Planning application consultation - P14/V2873/O, Valley Park Didcot.

B4493 Southern Site Access Proposed Roundabout

Drawing no. 10219-HL-61-100-004, rev C

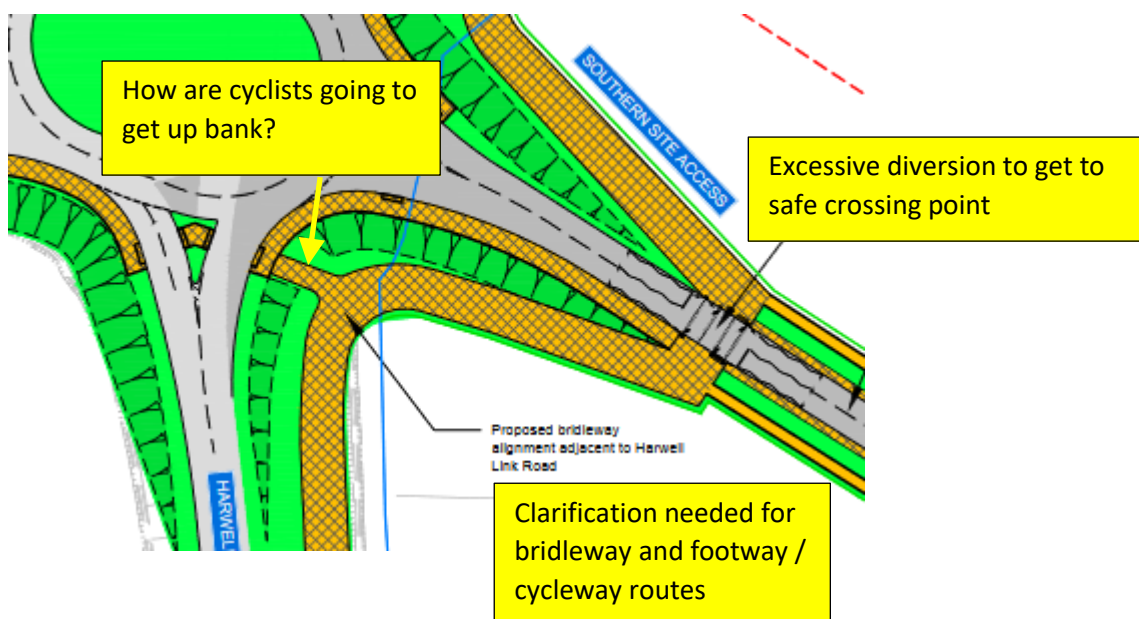
Despite previous objections about the roundabout, the current proposed design has not significantly changed from previous versions: 10219-HL-61, rev E.

- The incorrect design standard has been used for the design.
The roundabout has been designed to conform to the Design Manual for Roads and Bridges (DMRB). DMRB is the Highways England standard for the design of motorways and trunk roads. None of the roads connecting to the roundabout are trunk roads and the design of the roundabout should take reflect that other modes of travel will be using the junction, not just motorised vehicles.

We note that the table detailing compliance with DMRB has been removed on the latest drawing revision, the geometry of the roundabout remains the same and hence DMRB compliant.
- The design does not take into account existing use of the B4493.
The B4494 has been designated as a premium cycle route by the County Council to allow cycle commuting to the Harwell Campus from Didcot and Didcot Parkway as well as for students from Harwell village to Didcot schools. The roundabout design is not suitable for any cyclist in any direction.
- The design requires cyclists and pedestrians to make excessive diversions down the roundabout arms to access safe crossing points.
- There is no detail about the ramp needed for cyclists to get up the bank to cross the Harwell Link arm.

- The refuges on the Southern Site Access Road and Harwell Link Road are not wide enough for cyclists to cross safely.
- Confusion over bridleway and footway / cycleway proposals.
There is an existing bridleway along the Harwell Valley Link Road crossing the B4493 and continuing north. This bridleway is separate to the shared cycle / pedestrian path. The proposed roundabout design drawing does not make it clear how the bridleway is different to the proposed footway and cycleway. The notes on the drawing only refer to a bridleway which is confusing and we cannot make a definitive comment on the design without clarification.

HarBUG believes that the roundabout should be redesigned with a focus on all travel modes, recognising that active travel has equal weighting with motorised travel. A compact roundabout design would be more appropriate or a 'Dutch' style roundabout, recently introduced into the UK in Cambridge.
